19 February 2016

ATA/Jefferson Middle School Rebuild
Lane County School District No. 4J
C.I.P. #410.436.003

ADDENDUM #6

CONSTRUCTION SEQUENCE - Phase 1A
 Spring 2016: 3/18/16 to 6/30/16
 (THIS DOCUMENT IS MEANT TO BE VIEWED IN COLOR)

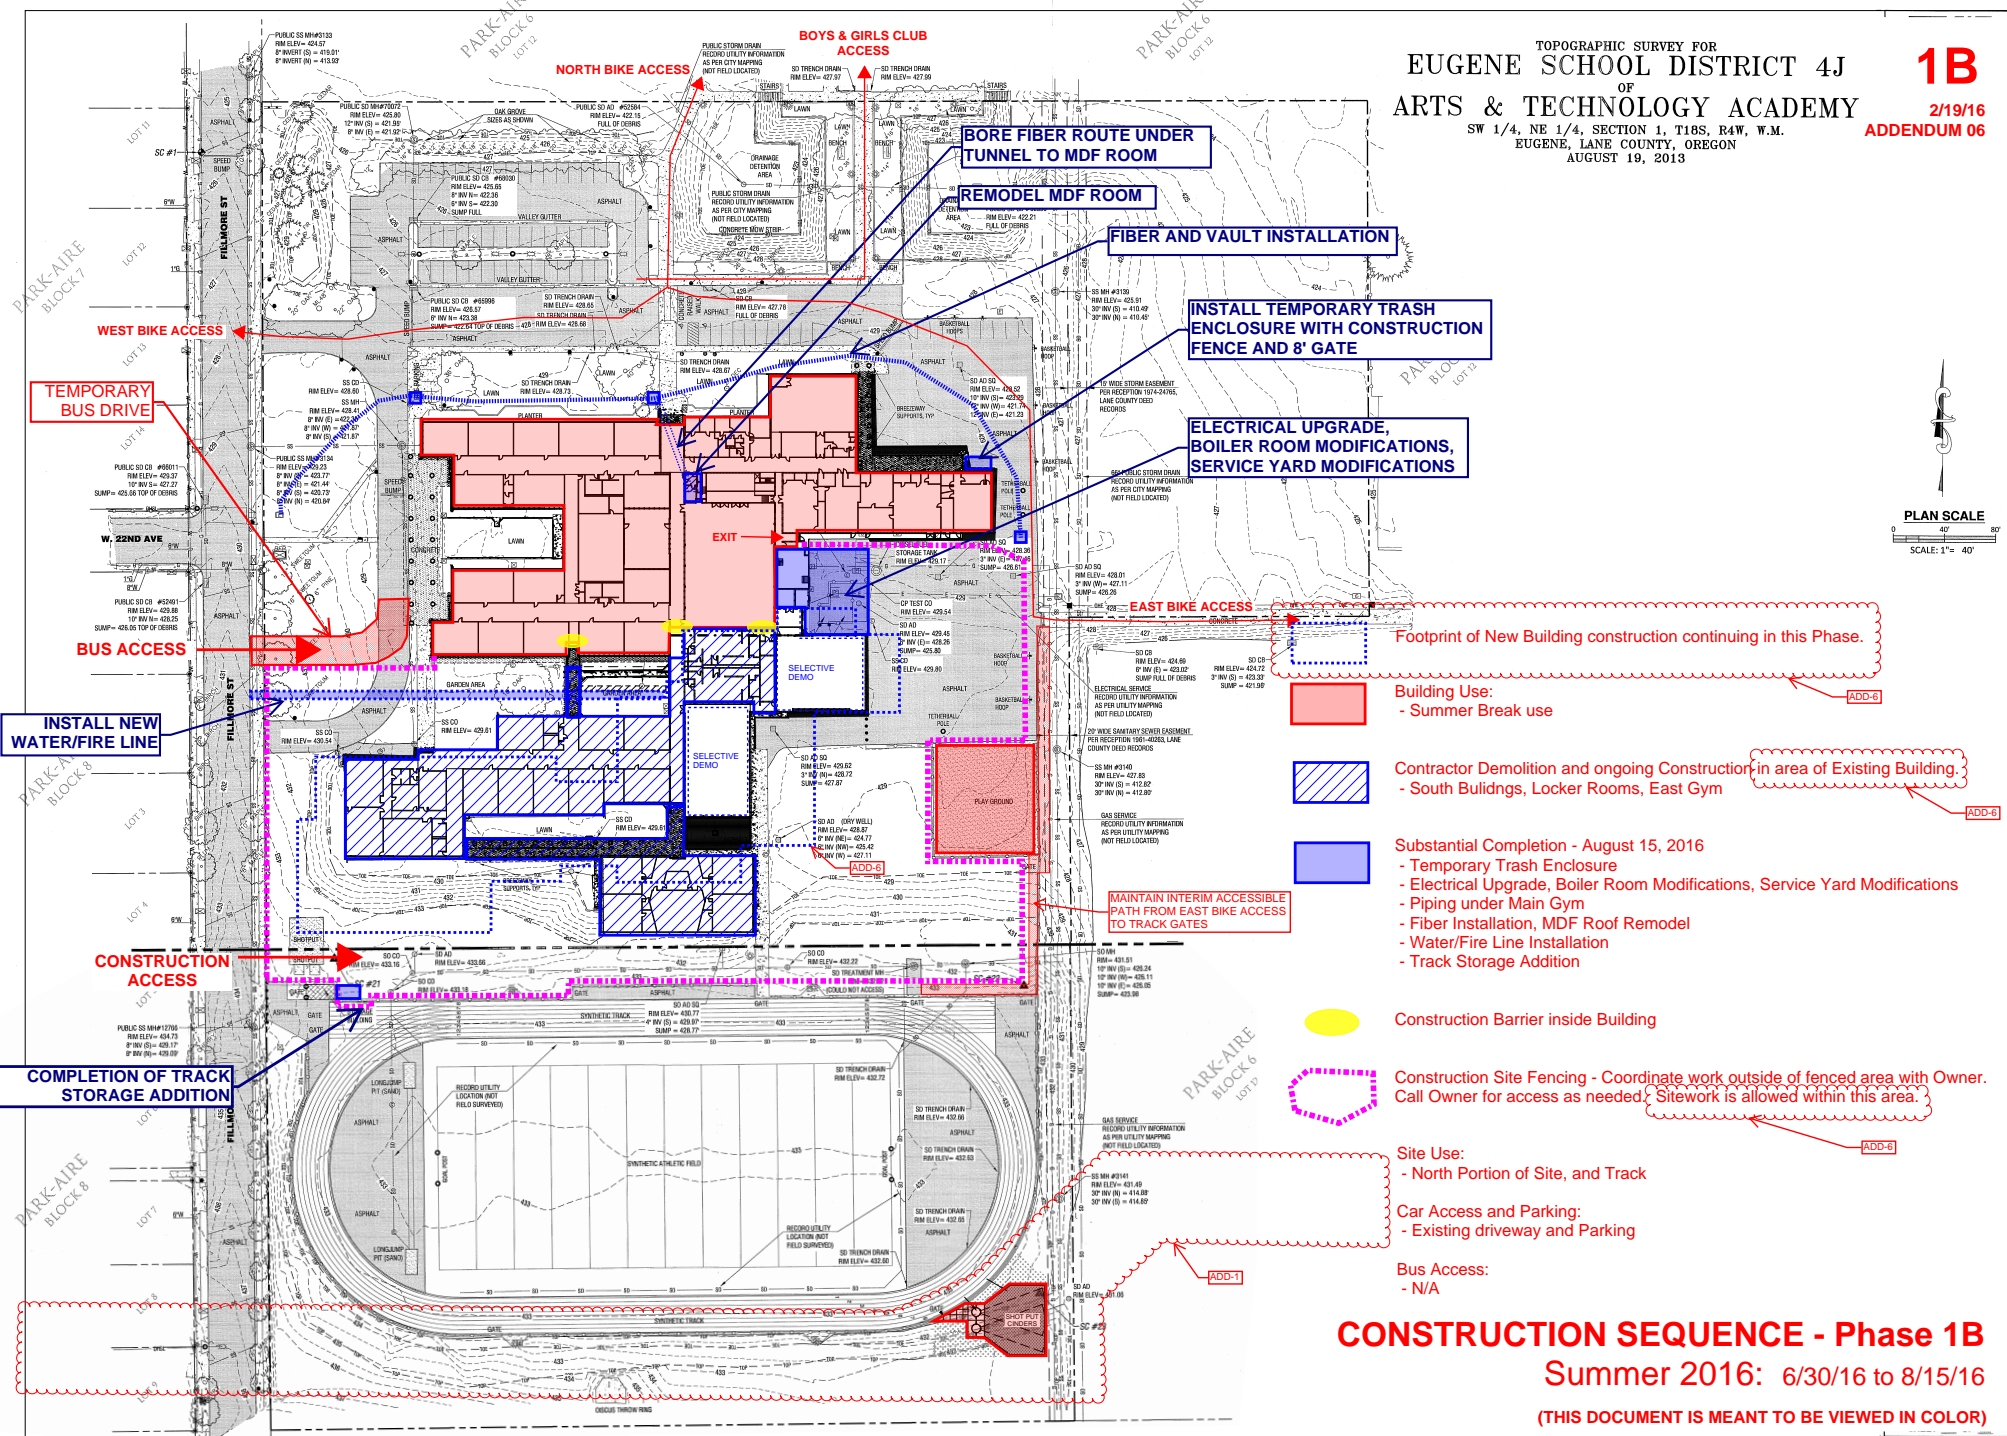
1. 011000 SUMMARY
 - A. 1.02.C.2.h., **REVISE** to read: "Track Storage Addition."
 - B. Construction Sequence - Phase 1A, **REVISE** per attached re-issued diagram to show outline of new Phase 1 building, and **ADD** note to indicate that sitework is also allowed to within the construction site fencing area.

Footprint of New Building construction to begin in this Phase.
